Pennsylvania Power & Light Company

SUSQUEHANNA STEAM ELECTRIC STATION  
DRINKING WATER PERMIT APPLICATION PWS 4085504 -  
RESPONSE TO PA. DER COMMENTS  
CCN 741326 FILE 012-3  
PLE- 7980

RE: Public Water Supply 4085504  
Susquehanna Stream Electric Station  
P. P. & L.  
Salem Township, Luzerne County

GRAVITY FILTER

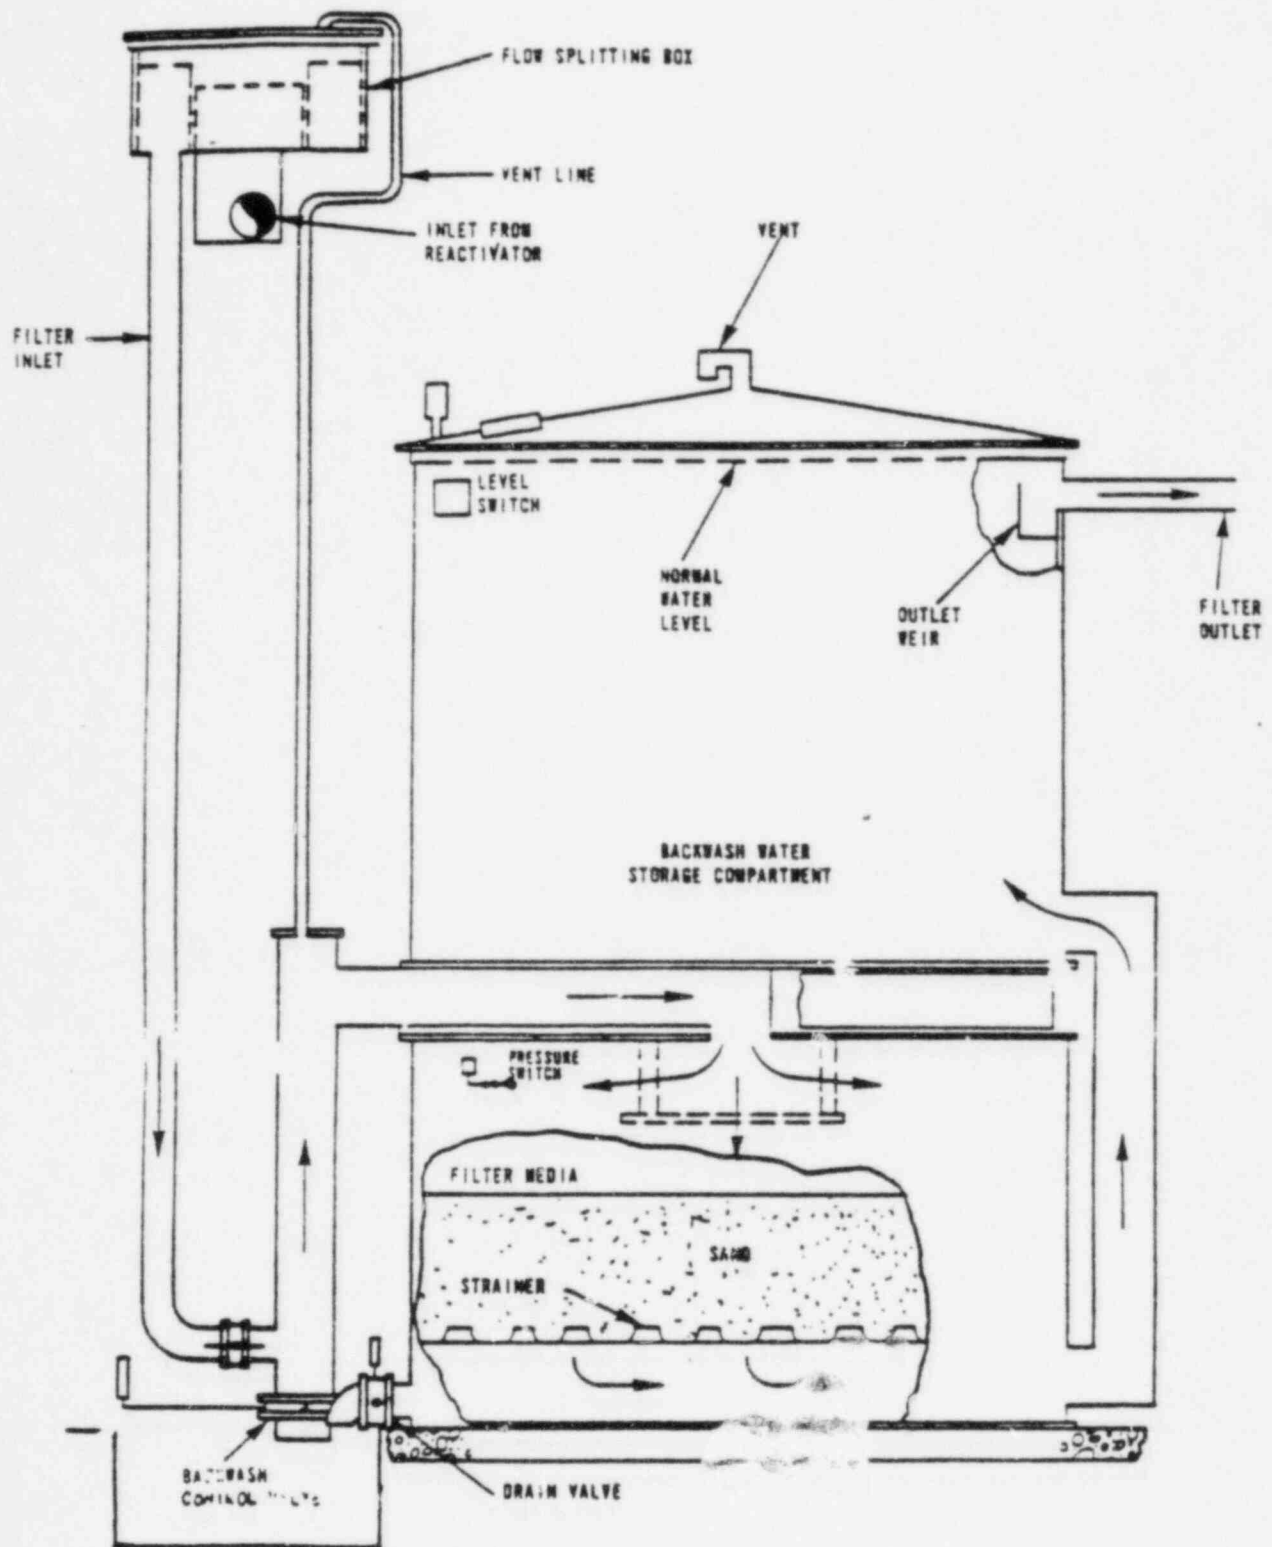
2. Please provide two legible copies of sheet T-21257-B entitled "Internal Assembly Reactivator with Clearwell".
3. Please provide a detail sheet of the gravity filters. The drawings should show at a minimum the location of underdrains and the supporting gravel bed depicting appropriate layers and depth. It should also show the depth of sand and anthracite in the filters. The wash water troughs, auxiliary surface wash, rate of flow controllers and all meters, valves, head loss gauge and sample taps should be shown on this filter detail. Our design manual recommends 21 inches of anthracite. Is it possible to add the additional 3 inches or would it be washed away during the backwash cycle?

Two mono-valve gravity filters are used to filter the clarified water leaving the reactivator before it enters the clearwell storage area. Each filter unit is a cylindrical carbon steel vessel, approximately ten feet in-diameter and houses a backwash storage compartment, filter section, and strainers as shown in Attachment 2.

Each filter consists of a bed of anthracite, 18" deep, on top of a 6" deep bed of sand. Currently it would be very difficult to add an additional 3" of anthracite filter media. In the past these filters have consistently produced water of acceptable turbidity. Below are listed a number of parameters describing the filters.

o	Number	2
o	Height	15'9"
o	Diameter	10'0"
o	Filter Bed Material	Anthracite
o	Filter Bed Volume	118 ft <sup>3</sup>
o	Filter Bed Depth	18"
o	Supporting Bed Material	Sand
o	Supporting Bed Depth	6"
o	Supporting Bed Volume	40 ft <sup>3</sup>
o	Flowrate (Clarified Water)	300 gpm
o	Flowrate (Backwash)	943 gpm
o	Backwash Duration	5 min.
o	Construction Material	Carbon Steel

SIMPLIFIED DIAGRAM OF REACTIVATOR

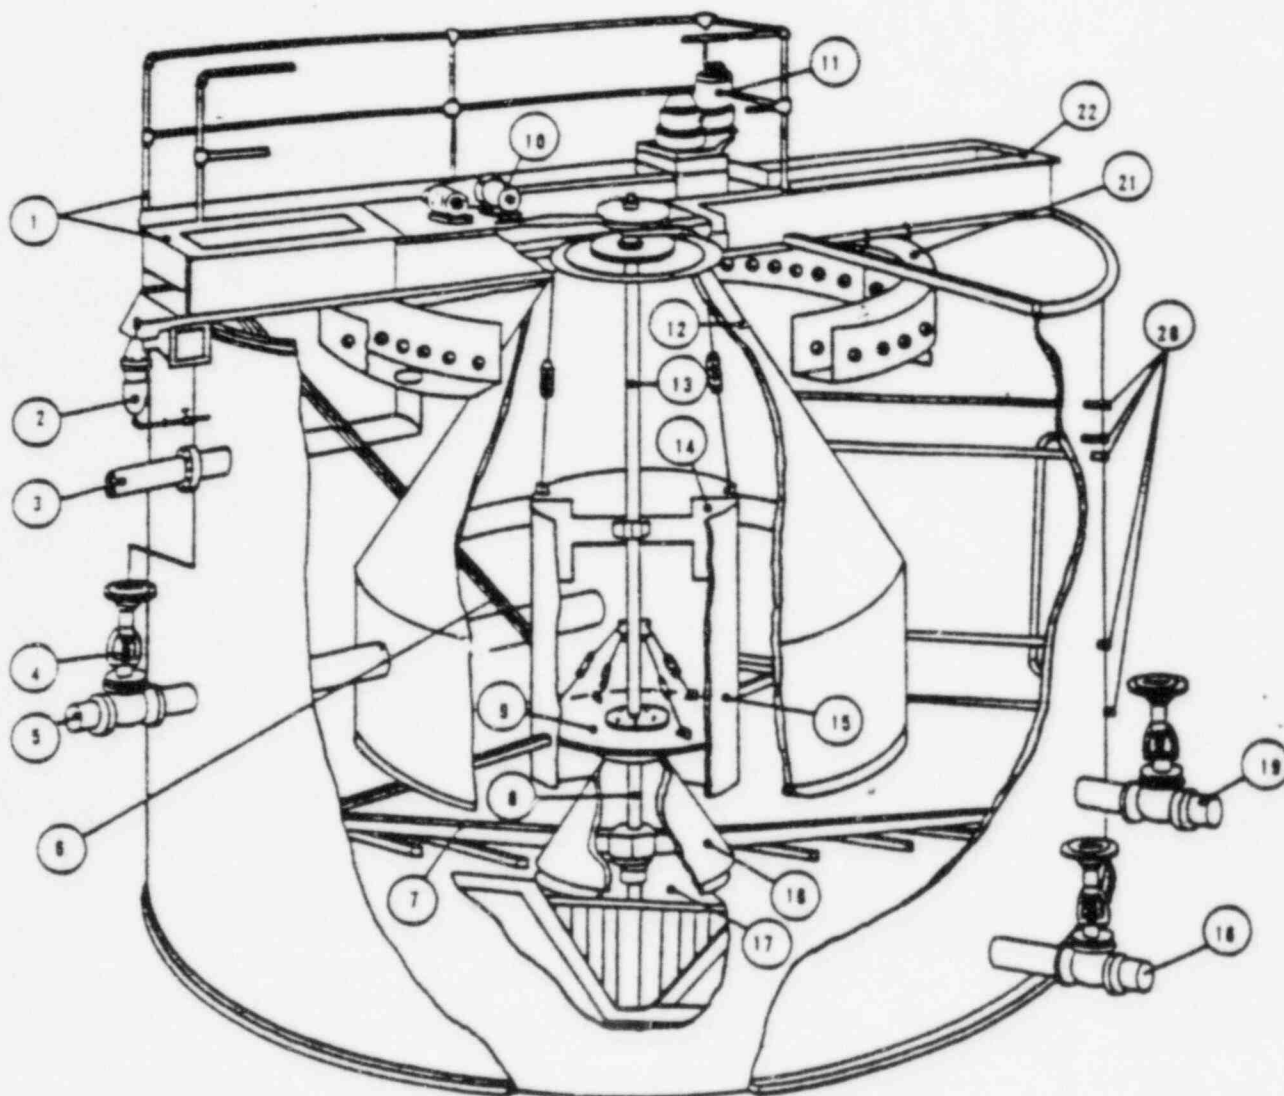
6. Is the detention time in the mixing and flocculation zone greater than 30 minutes? This excludes the detention time in the coagulation zone.
7. I was unable to determine how the sludge was recirculated in the solids contact clarifier from Drawing M-117 SH 1. Perhaps it will be obvious when you provide Drawing T-21257B. If not, please provide an explanation.

6. There is a variable speed impeller pump which positively mixes raw water, treatment chemicals, and previously-formed precipitates in the draft tube or primary mixing zone and recirculates this mixture through the secondary flocculation zone located beneath the hood suspended in the reactivator. (Attachment 4 and 5). The recirculation system is designed to recirculate three to five times the design output flow. Detention time within this hooded section is approximately 30 minutes at the design maximum flow of 300 GPM.

7. The reactivator is a positive, internal recirculation, upflow unit of the high-rate solids contact type. A cut-away view of the reactivator is shown in Attachment 4. Water to be treated enters the central uptake draft tube where it is mixed with chemicals, previously formed precipitates and recirculated sludge. The recirculating flow path is shown in Attachment 5. The recirculation impeller/agitator mixes the chemicals, water, and precipitates thoroughly while imparting an upward flow in the draft tube. The mixture then passes out of the top of the draft tube into the slow mixing zone where maximum chemical contact is achieved. From this zone, the water and precipitates may re-enter the draft tube at the bottom for further mixing and treatment, or may enter the quiescent separation zone.
